## ODOR CONTROL FACILITY IMPROVEMENTS PROJECT

Solicitation Number: CO-00704

Job No.: 22-6506

### ADDENDUM 2

**C13**  
 SHT 13 OF 34

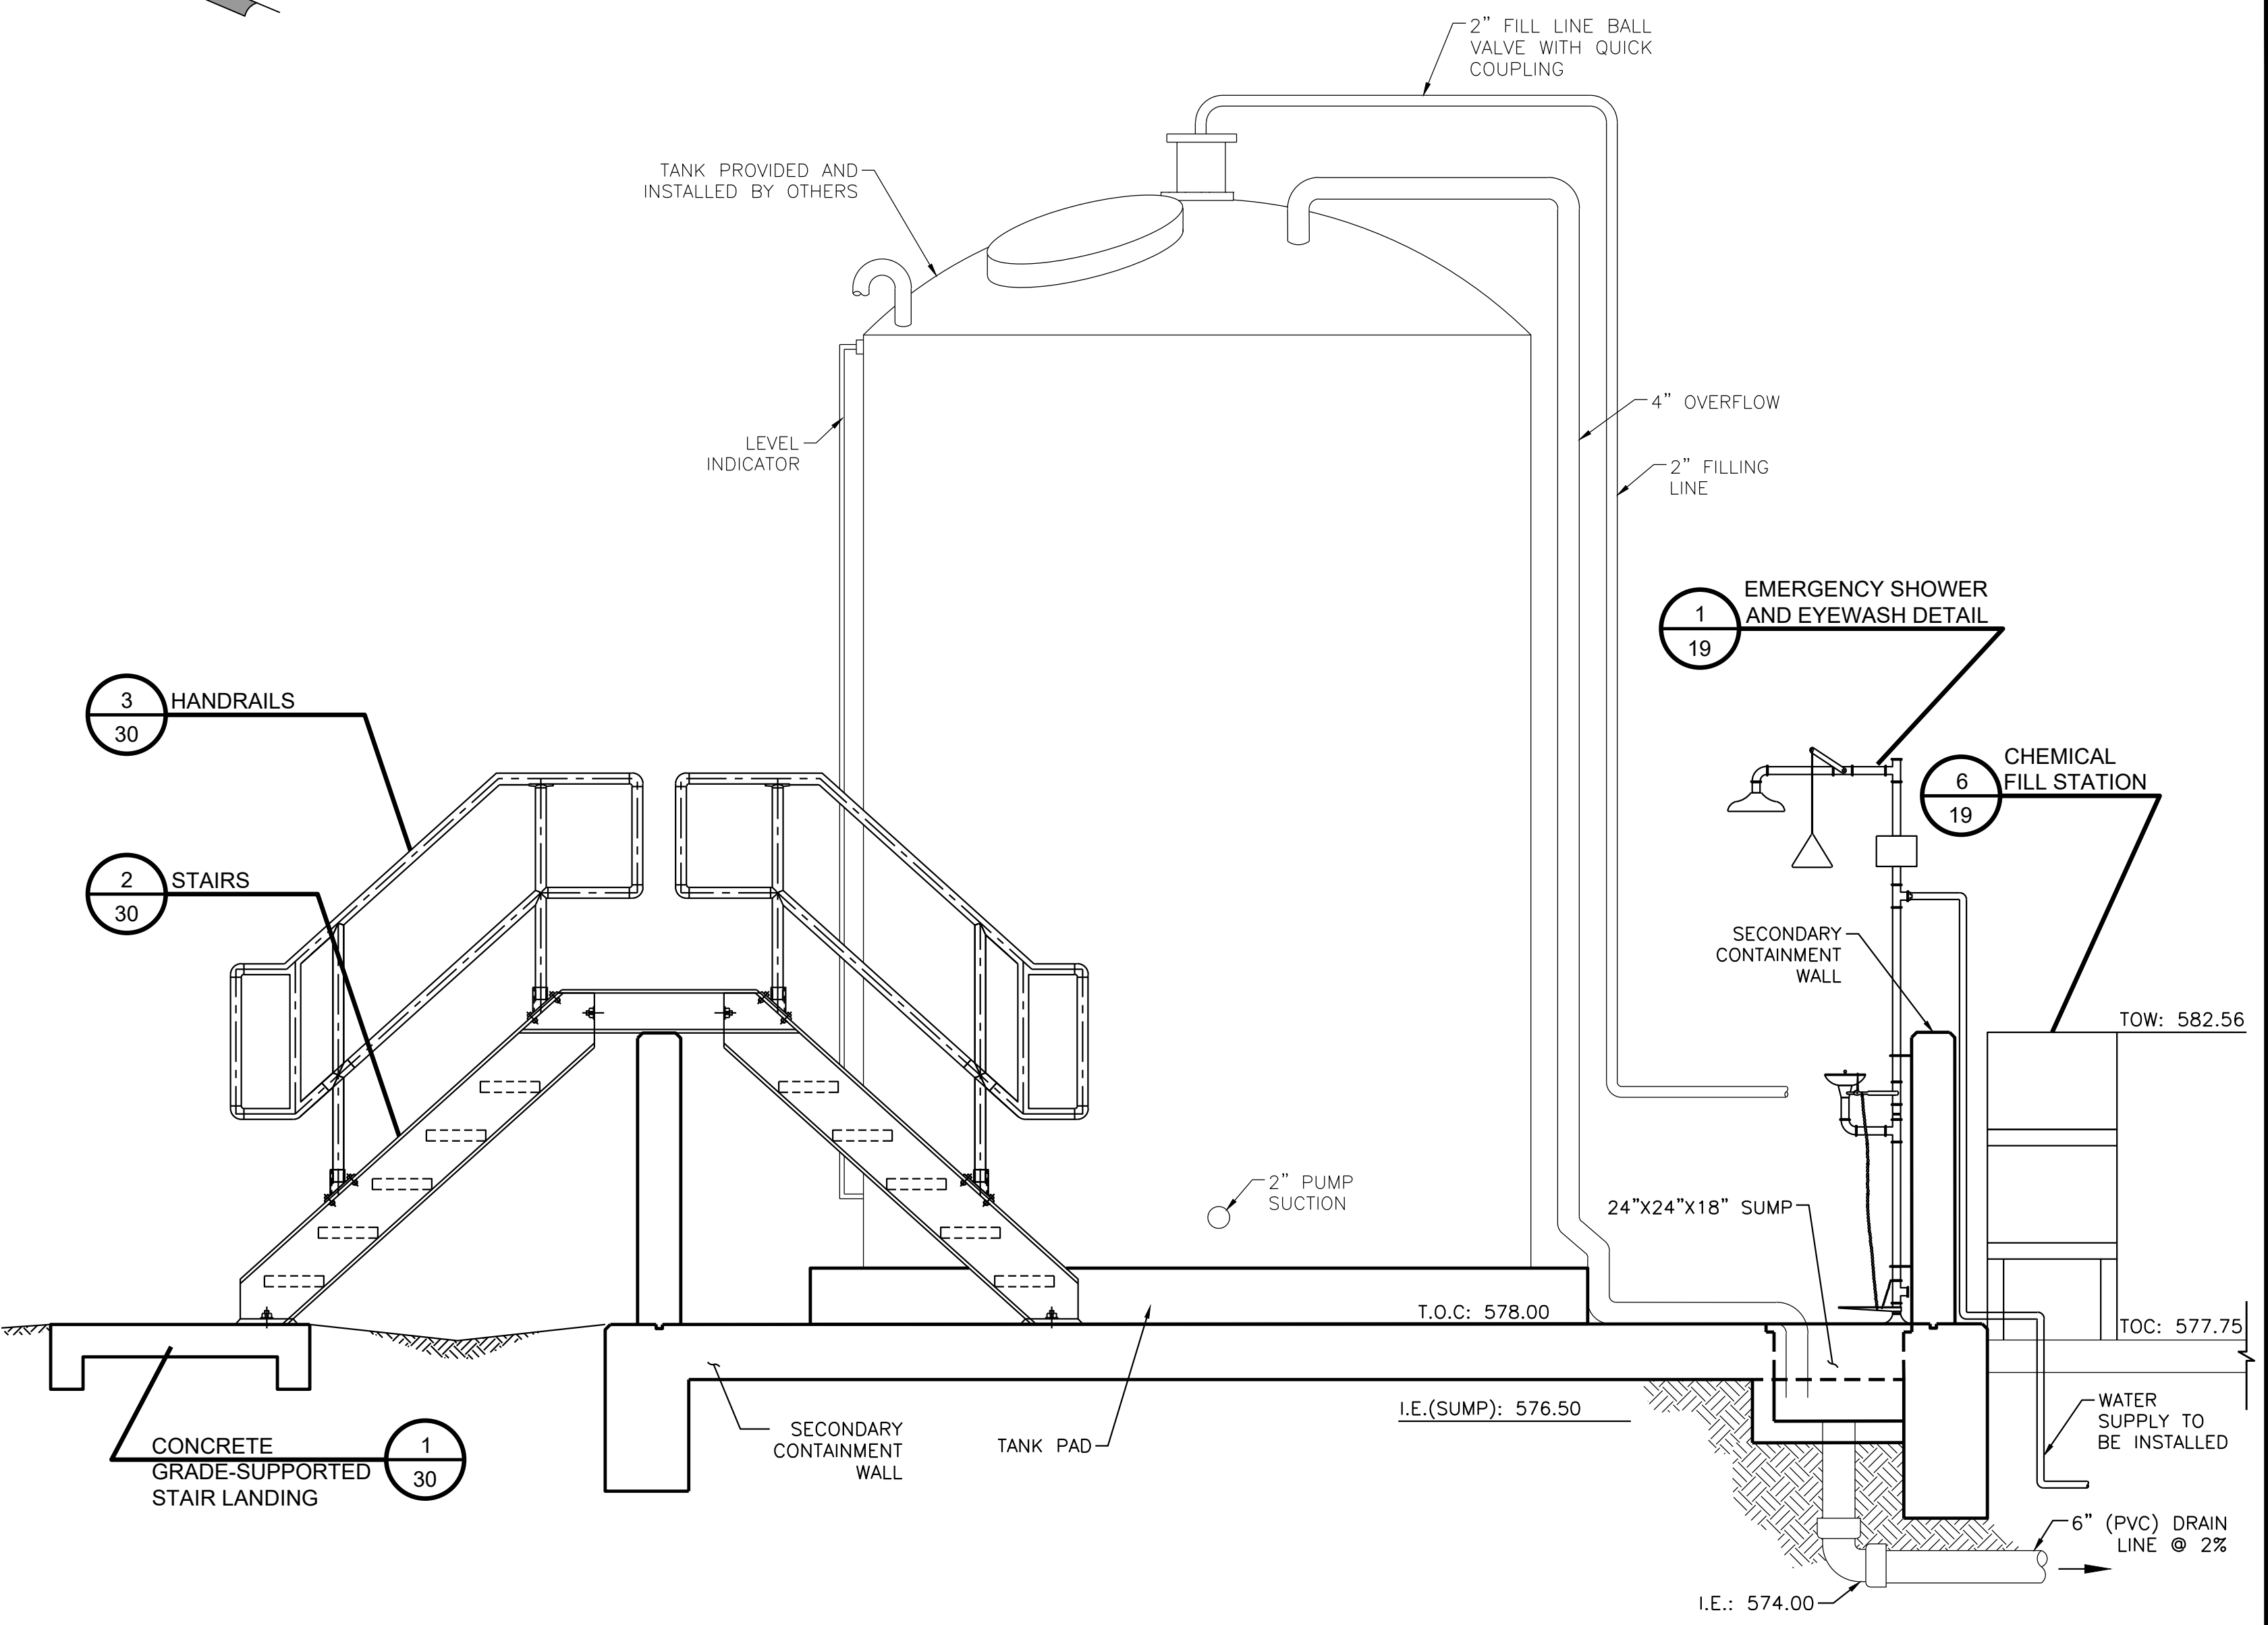
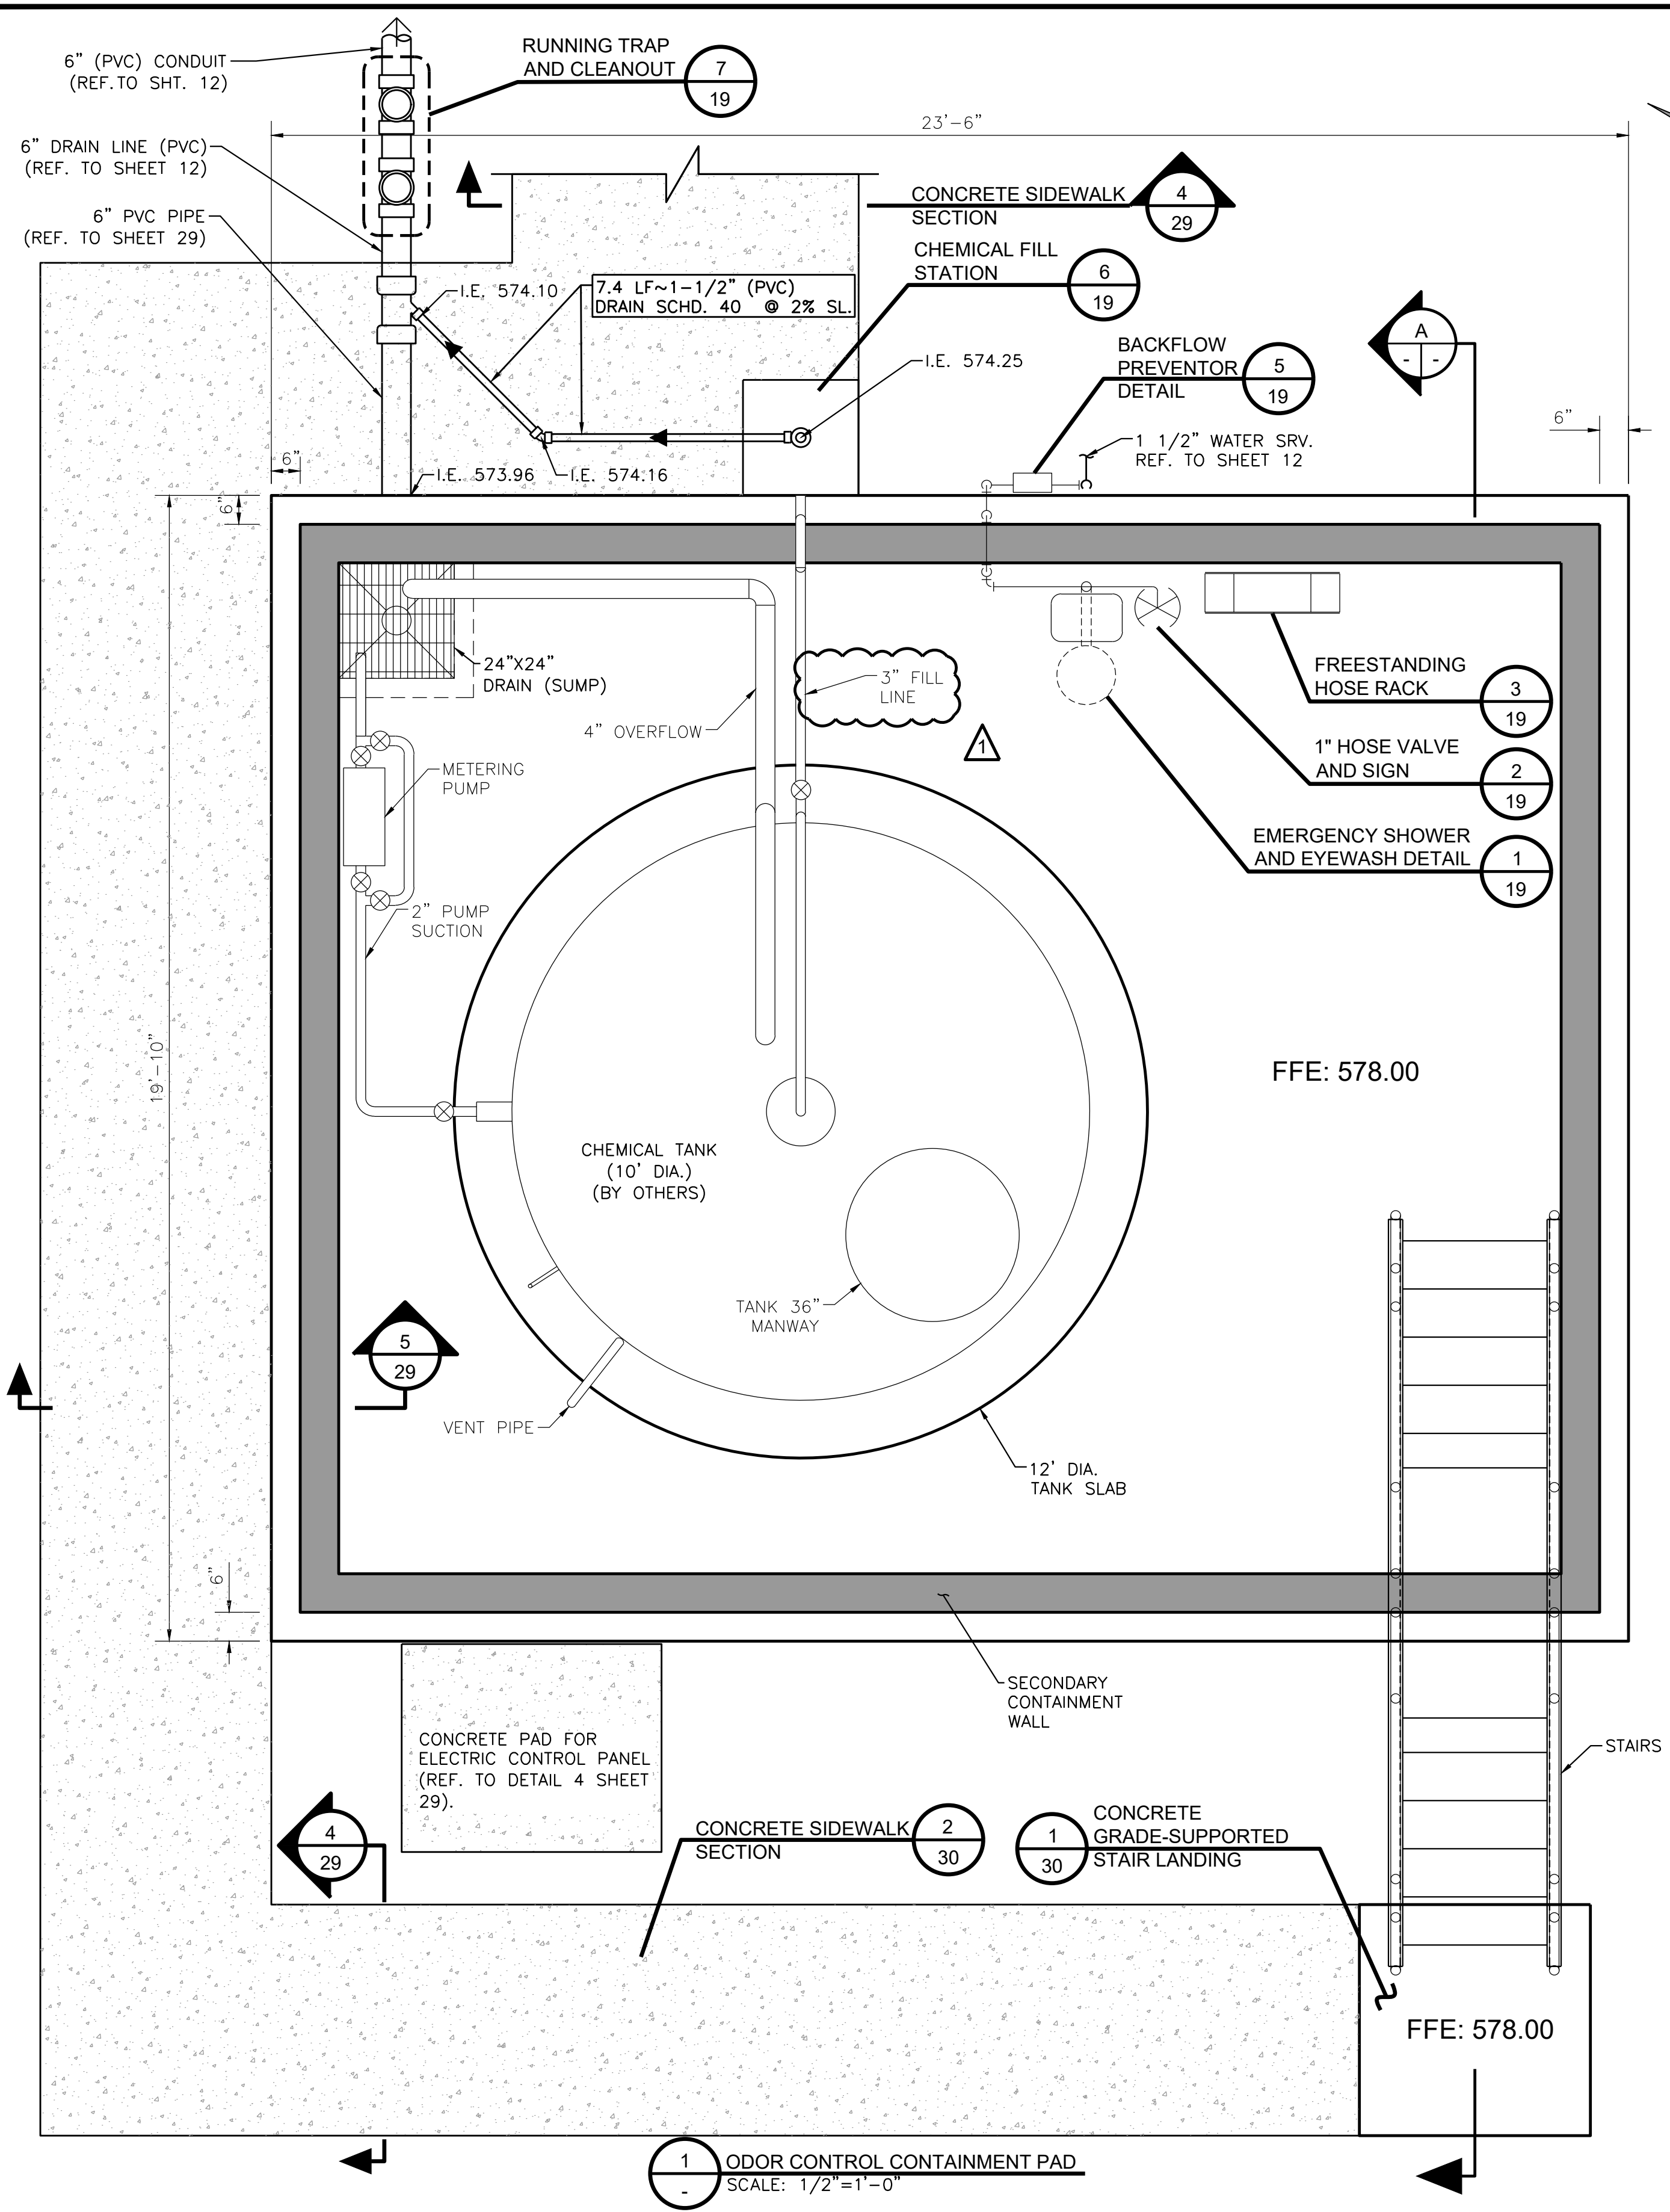
5. Brooks Drawing C13, Mechanical and Structural Plan and Section, remove in its entirety and replace it with the revised version attached to this addendum.

- SHEET NOTES:**
- CHEMICAL STORAGE TANK, CHEMICAL METERING PUMPS, CONTROLS SKID, CHEMICAL INTERCONNECTING PIPING, 3" FILL LINE FROM THE CHEMICAL FILL STATION TO THE CHEMICAL TANK, AND VALVES WILL BE PROVIDED AND INSTALLED BY OTHERS (SAWS VENDOR) UNDER A SEPARATE CONTRACT.
  - ALL OTHER WORK TO INCLUDE SECONDARY CONTAINMENT STRUCTURE, TANK SLAB, DRAIN SUMP, STAIRWAY, EMERGENCY SHOWER AND EYEWASH STATION, HOSE VALVE, FREESTANDING HOSE RACK, CHEMICAL FILL STATION, FILL STATION 1 1/2" DRAIN LINE, FILL STATION BALL VALVE W/QUICK COUPLING, PIPE BOLLARDS, WATER SERVICE LATERAL, AND PVC DRAIN LINE WILL BE PROVIDED BY THE CONTRACTOR.
  - REFER TO SHEET 19 FOR MECHANICAL DETAILS.
  - REFER TO SHEETS 28, 29 AND 30 FOR STRUCTURAL DETAILS.
  - SECONDARY CONTAINMENT CONCRETE STRUCTURE WILL BE PAINTED BY THE FERRIC SUPPLIER UNDER A SEPARATE CONTRACT.

**6 CHEMICAL FILL STATION**  
SCALE: NONE

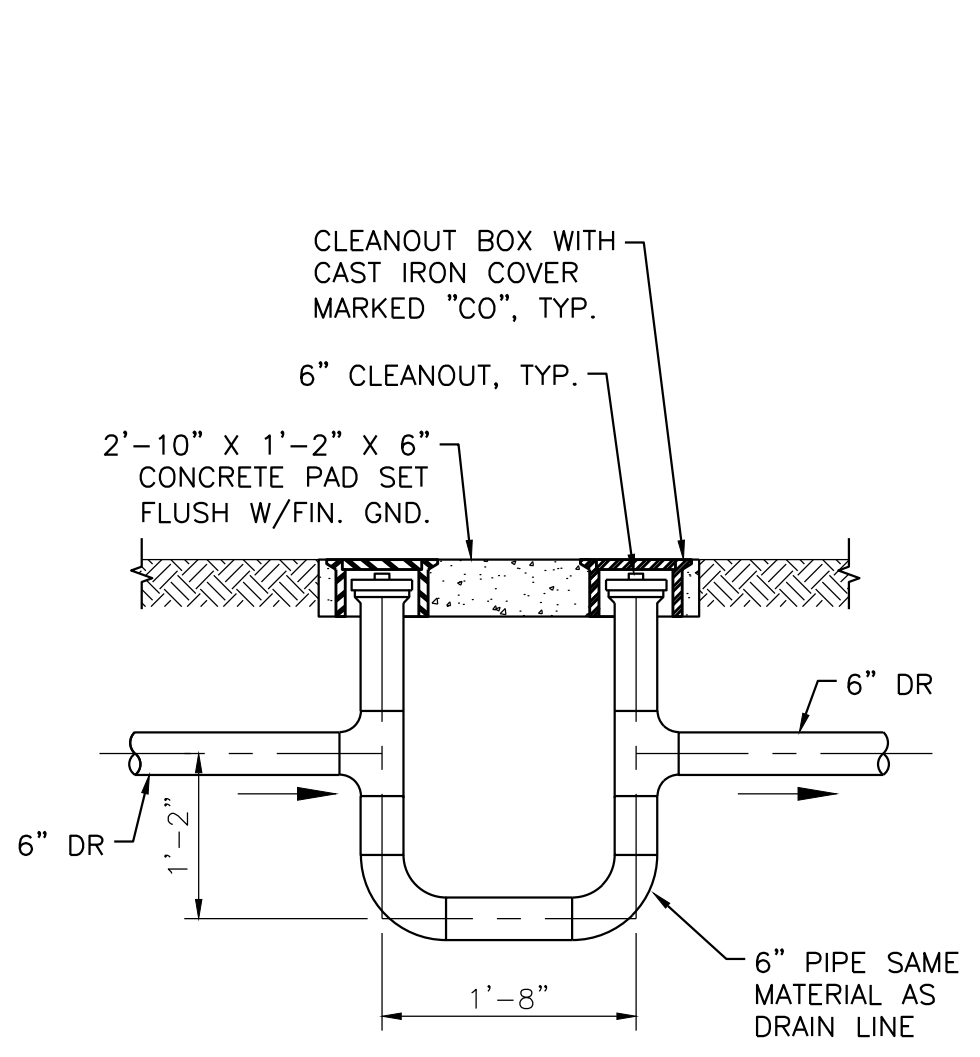
*The Prime Contractor is responsible for installing the Chemical Fill Station, 1 1/2" drain line, and 2-inch ball valve, quick coupling, and 2-inch fill line to and including the 3" X 2" Reducer. The SAWS Vendor will supply and install the 3-inch Fill Line from the Chemical Fill Station 3" X 2" Reducer to the Chemical Tank.*

6. Brooks Drawing C14, Brooks Tree Preservation Plan, remove in its entirety and replace it with the revised version attached to this addendum.
7. Leon Creek WRC and Brooks Drawing C19, Mechanical Details, remove in its entirety and replace it with the revised version attached to this addendum.
